Water Resources Department

Re: Silver Creek Dam (S-66) – Inspection Summary

Low level outlet, toe drains, weirs

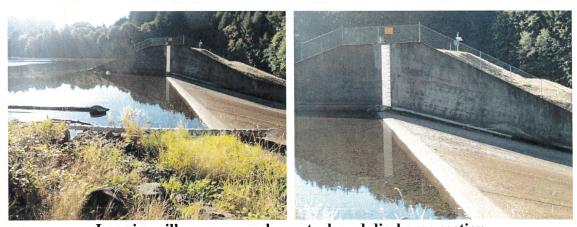
At the time of the inspection, there was a minor amount of seepage flow through the embankment and into the toe drains. The seepage was clear of sediment which suggests that it is normal seepage. Most earth fill dams have seepage so a certain amount of

seepage through the embankment from the reservoir is normal. In addition, there was an area below the toe of the dam near the left abutment that was wet. There was no flowing or standing water but the soil was moist. This area was located off of the dam and likely is seepage from the reservoir that is moving underneath the dam. This type of seepage infrequently occurs on embankment dams and is less important from a dam safety perspective than the seepage through the embankment mentioned above.

The low level conduit outlet was partially submerged and does not close completely. In review of past inspections since 2001, it appears that this situation has not changed much. At some point this leak should be addressed.

- 1. Continue regular vegetation management
- 2. Monitor the repaired spillway joint for changes
- 3. Continue to monitor seepage
- 4. Investigate leakage through the low level conduit
